This Service Information bulletin supersedes SI B26 01 14 **dated June 2014**.

Service Action: Inspect Front Driveshaft

E70 (X5)

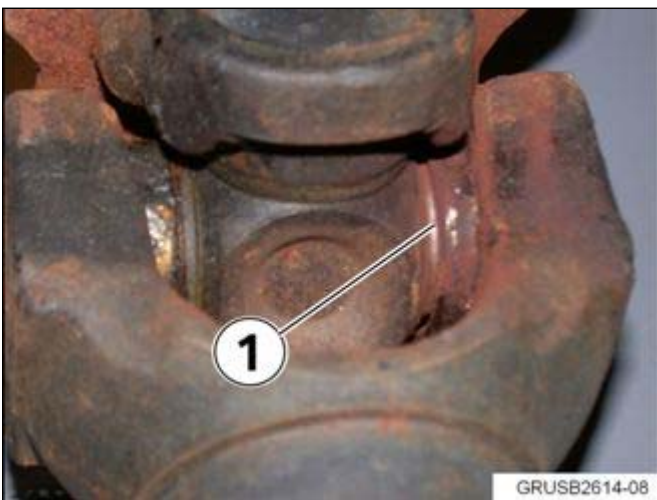
1. Checking the front U-joint:

Hold the input flange (1) on the front differential and check for radial play in the U-joint (2). There should be no excessive play.

2. Checking the rear U-joint:

Hold the output flange (1) on the transfer case and check for radial play in the U-joint (2). There should be no excessive play.

3. Rotate the driveshaft 90° and repeat steps 1 and 2. Rotate the driveshaft another 90° and recheck for play. Rotate a total of four times (the driveshaft has now been rotated 360° total). There should be no excessive play in the U-joints.

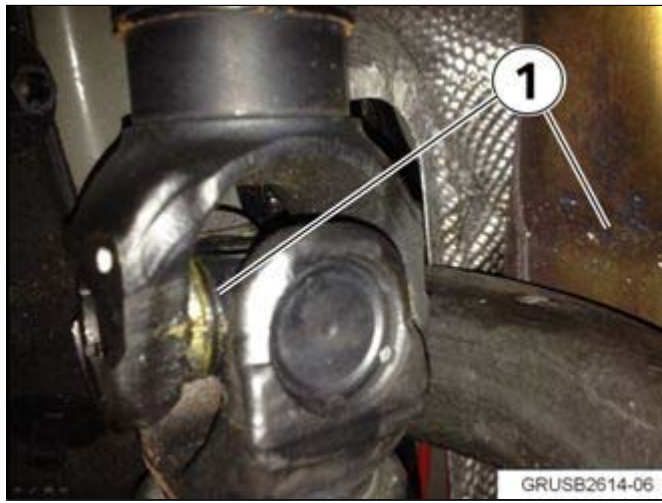
NEW If no play is found in the U-joints, a visual inspection of the U-joint needle bearing seals on both front and rear U-joints will be necessary.

1. **NEW** There should be no cracking or damage at the bearing seals (1).

2. **NEW** There should be no exposed needle bearings (1).

3. **NEW** There should be no excessive rust at the bearing seals (1). Note: There will be rust buildup on the driveshaft and mounting flange on some driveshafts. This rust is normal. Only excessive rust on the bearing seals indicates the seal may fail.

NEW If any of the above conditions are present, replace the driveshaft. Refer to Repair Instruction 26 20 000, "Removing and installing front propeller shaft as of 4/2010."
